DATE: December 26, 2018  
TO: Prospective Respondents  
FROM: Pamela Paulk, Sr. Procurement Specialist  
SUBJECT: Addendum #2 to Invitation for Bid # 33945, Lake Apopka Levee Improvements

UPPER OCKLAWAHA RIVER BASIN  
 LAKE APOPKA LAKE LEVEE IMPROVEMENTS  
 ORANGE COUNTY, FLORIDA

OVERALL SITE PLAN

FILE NAME:  
 CZLALLOSPN.dwg  
 PROJECT NO.: \_\_\_\_\_  
 SHEET:  
 C2

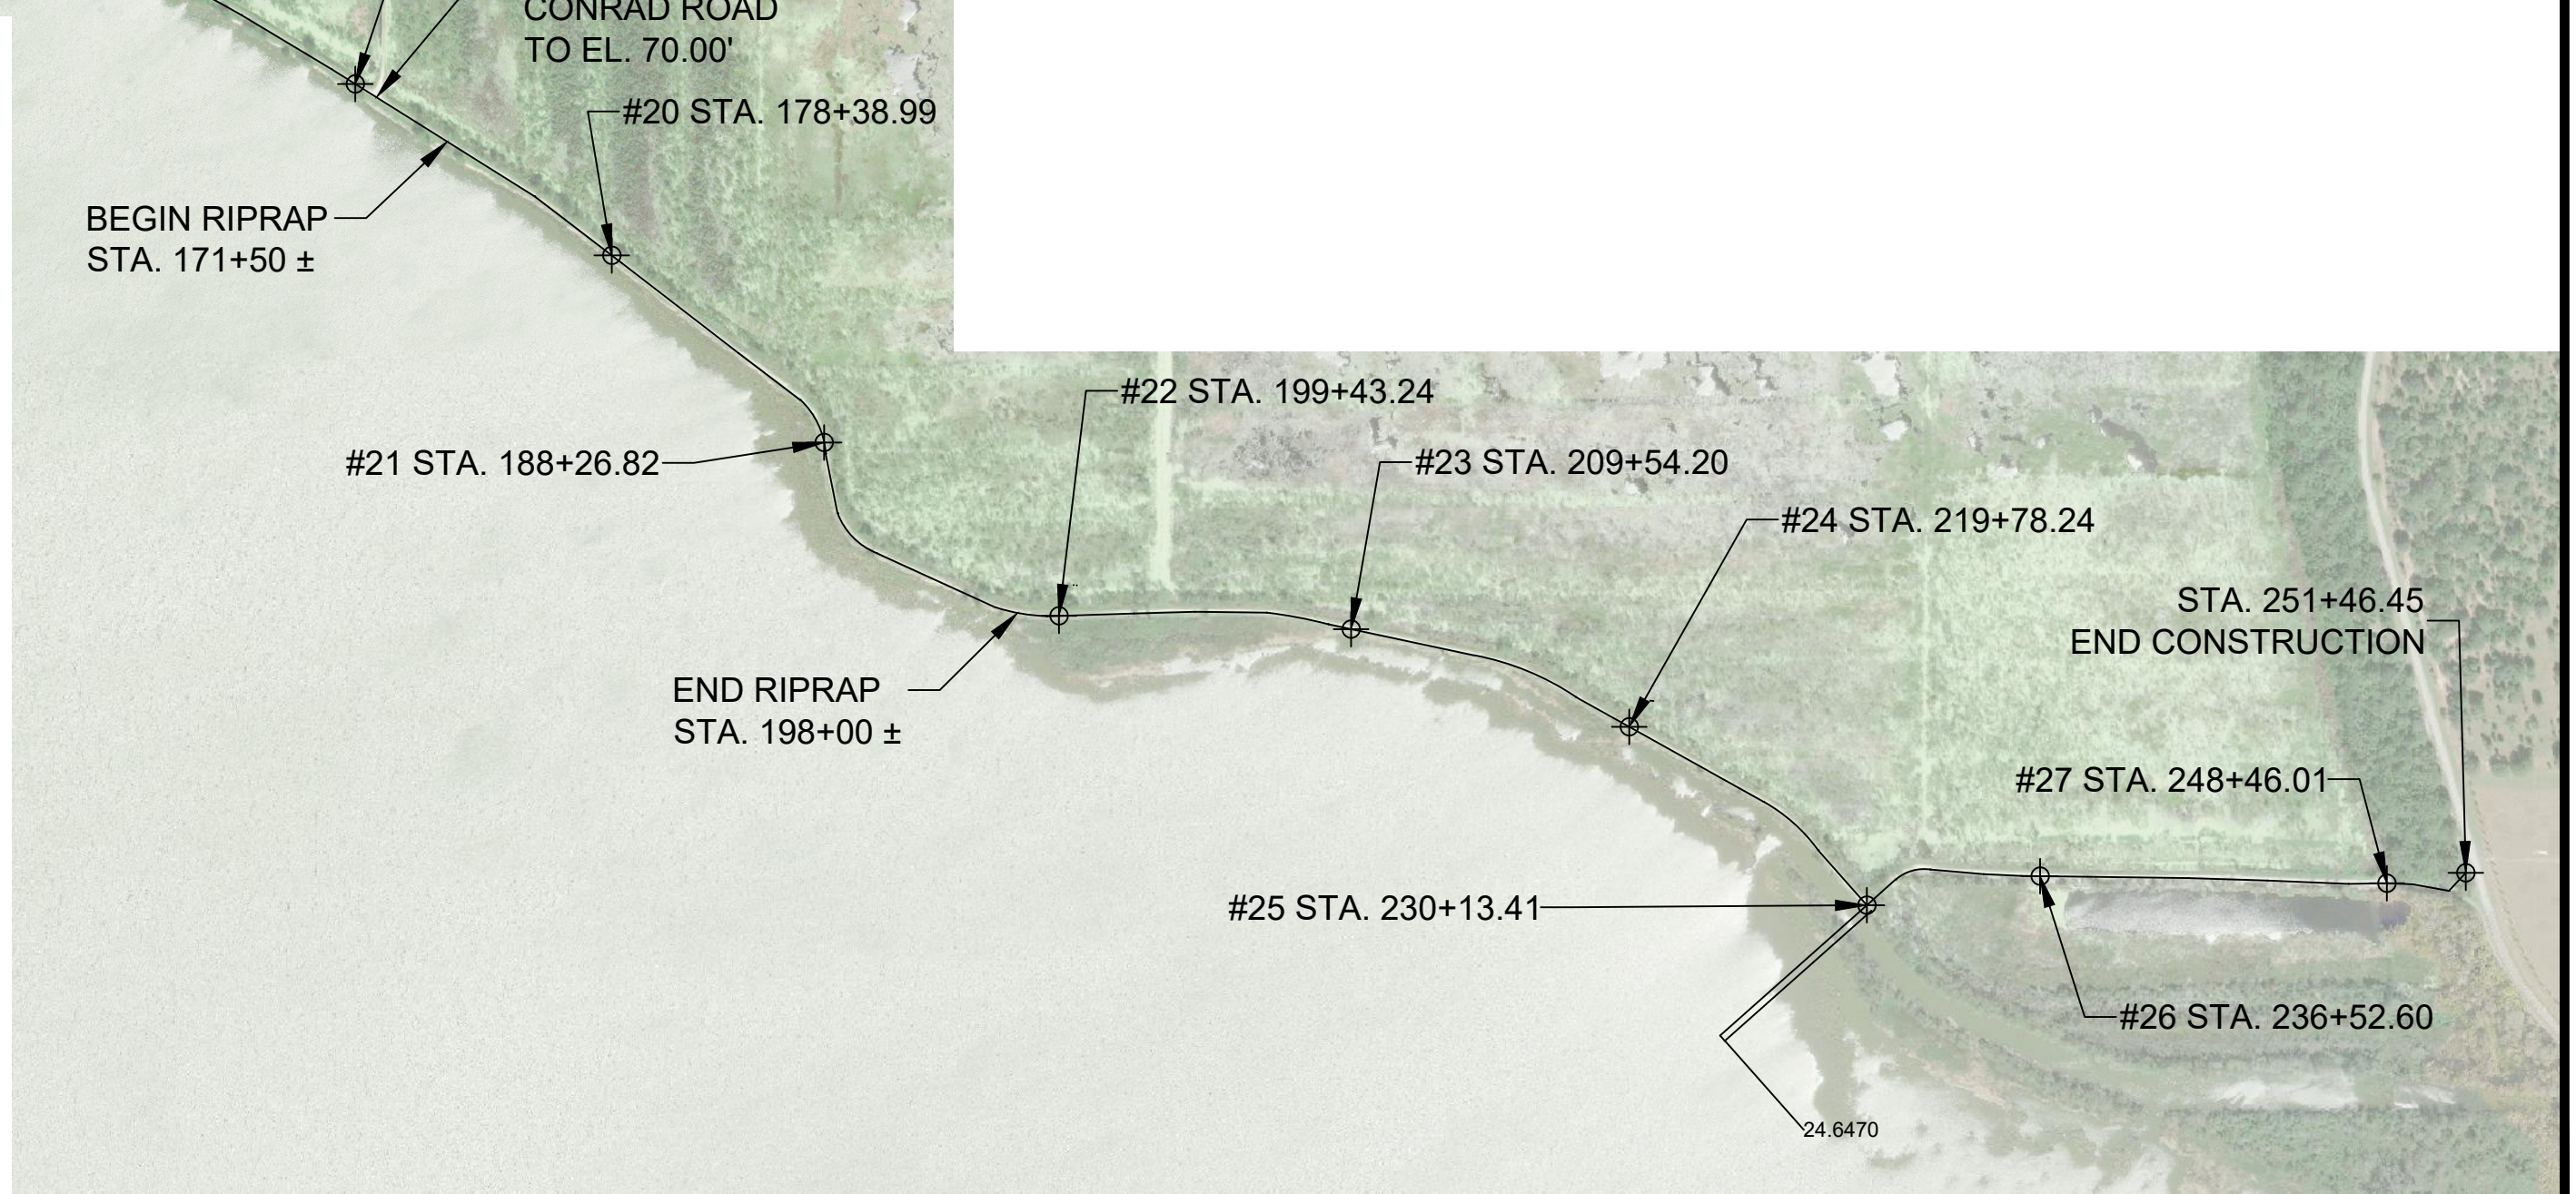
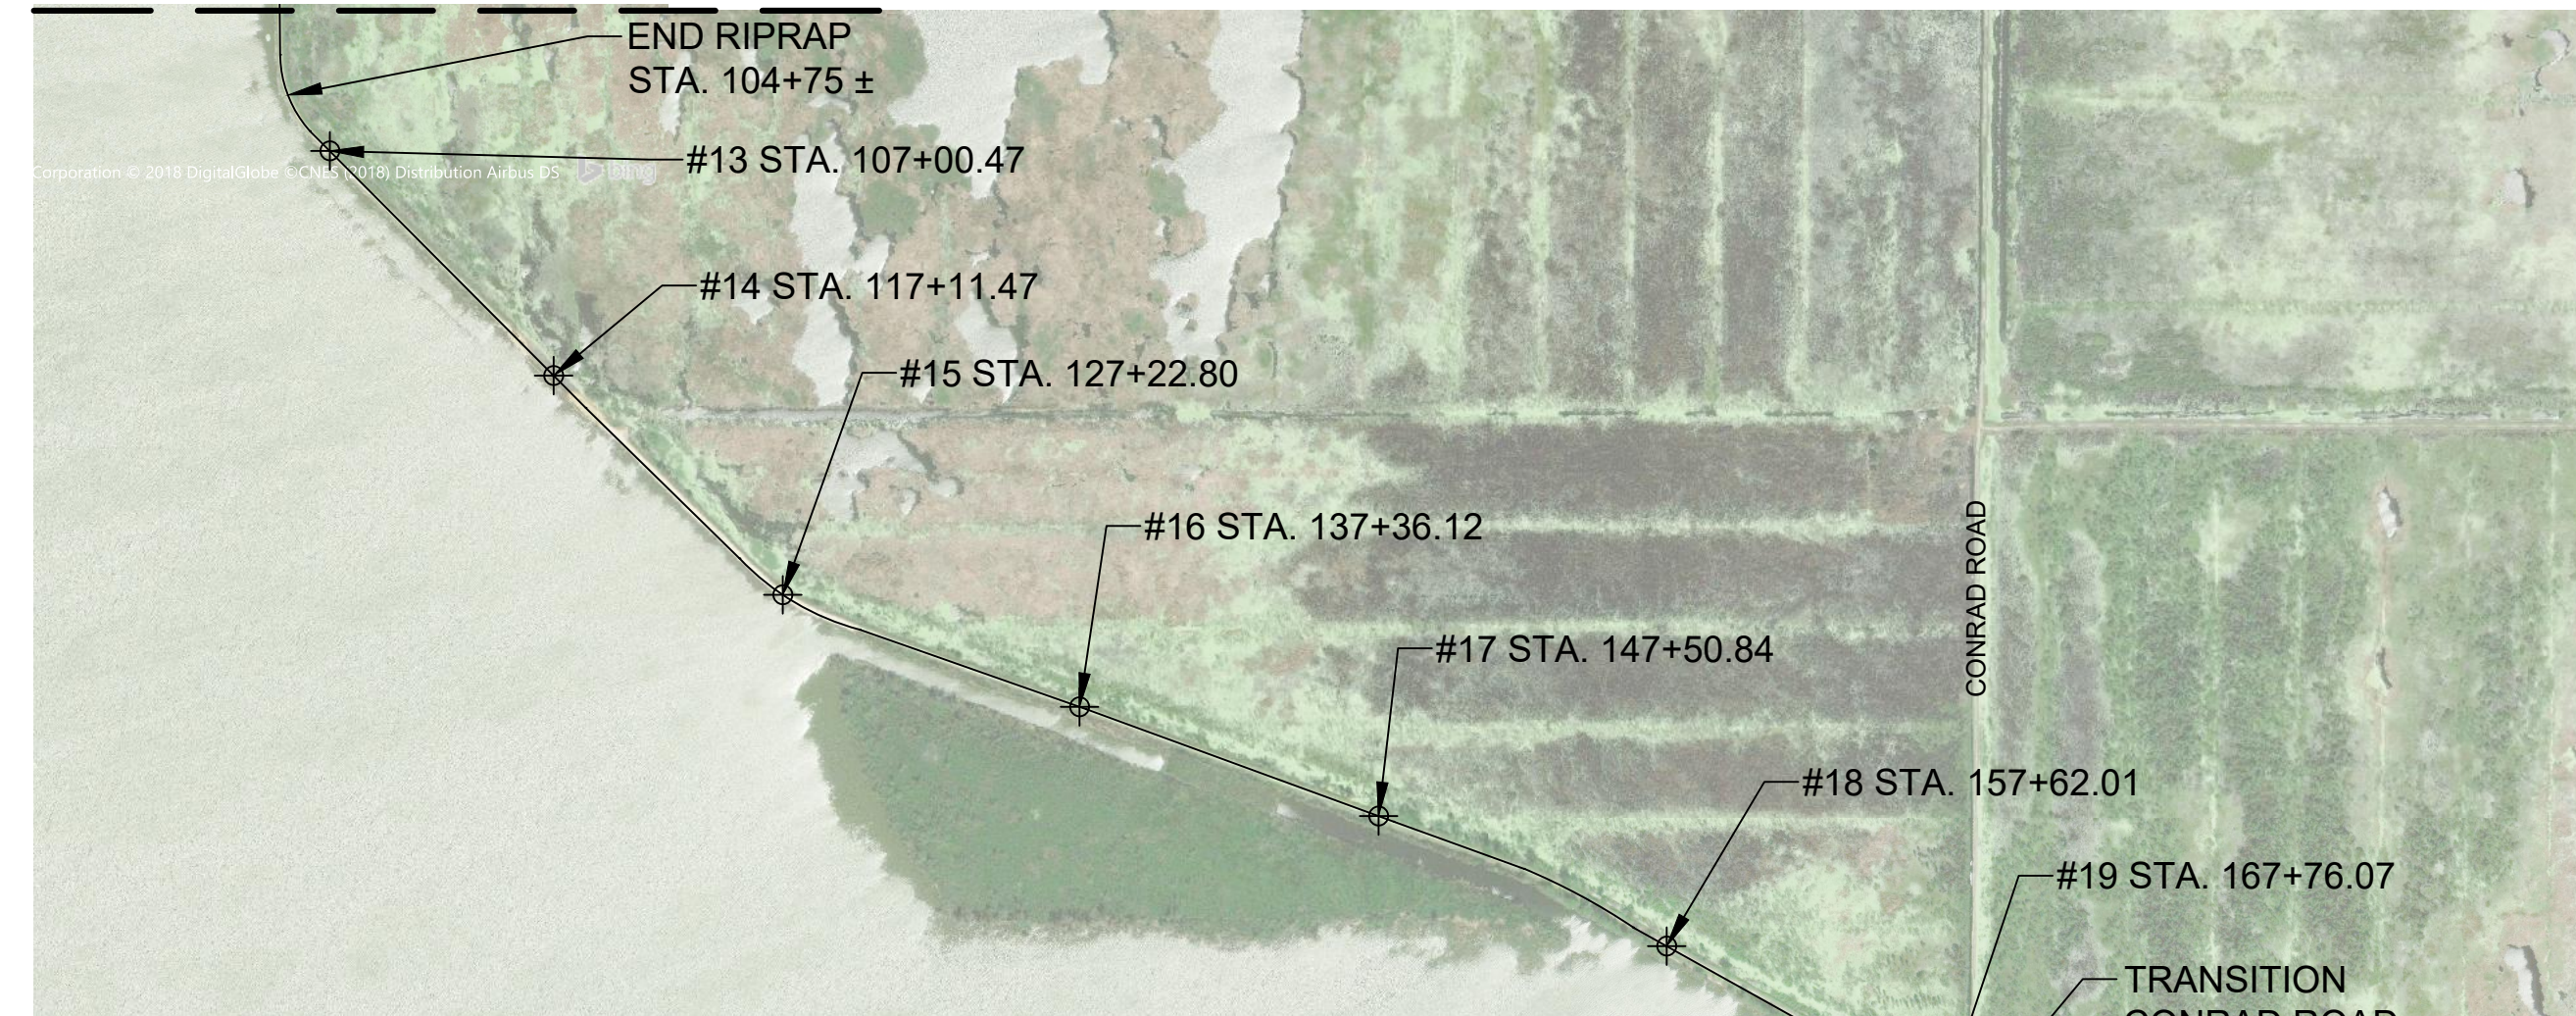
1. A revised sheet C2 is attached that indicates the location of cross-sections 1 and 2.
2. Note 11 on sheet C10 shall be deleted on the drawings issued for construction, and replaced with the following:
